## 9992-DEC Firmware Version 0.8.X Release Notes

**Baseline version: 0.7.0**

#### Version 0.8.5

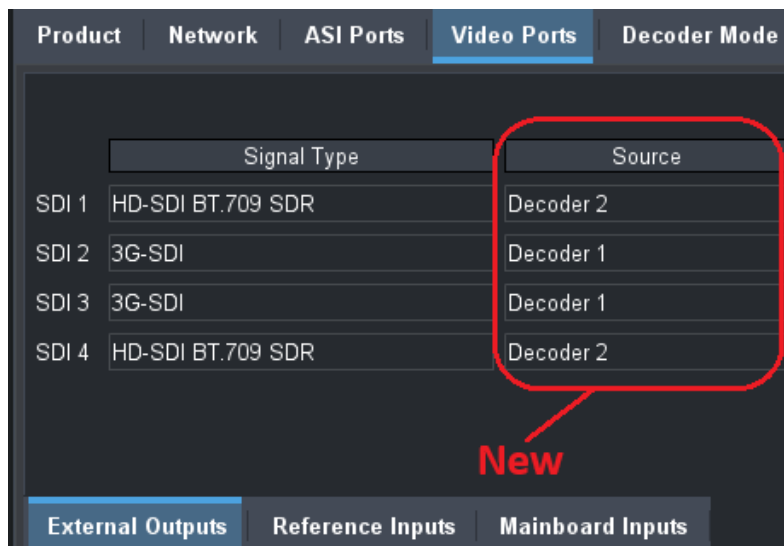
- When genlock is enabled and signal is lost, the decoder can either put up a flat field or freeze the last frame. In this version, the flat field color can be specified either as YCrCb values or basic colors:

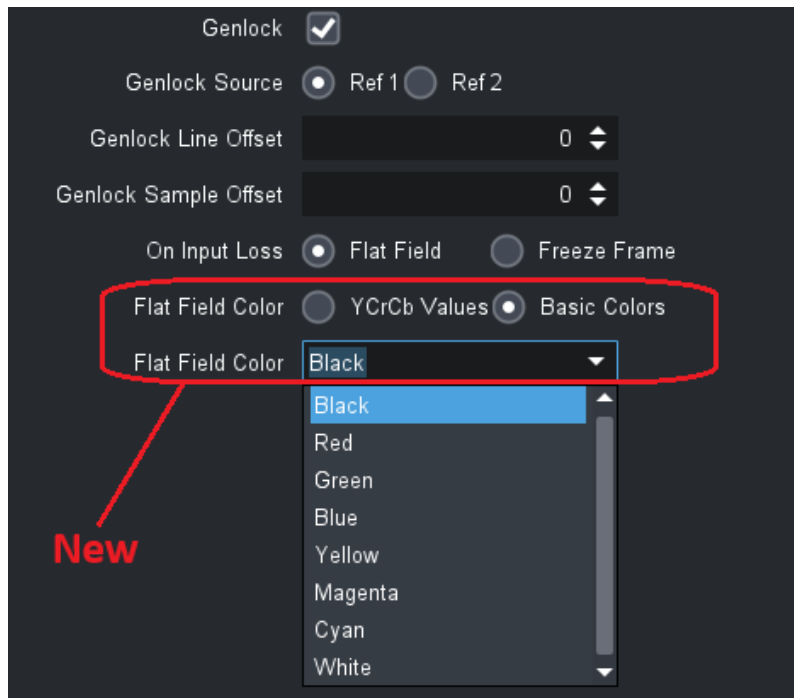
- In this version, the **Video Ports** top tab, **External Outputs** bottom tab has been enhanced to show the channel signal source:
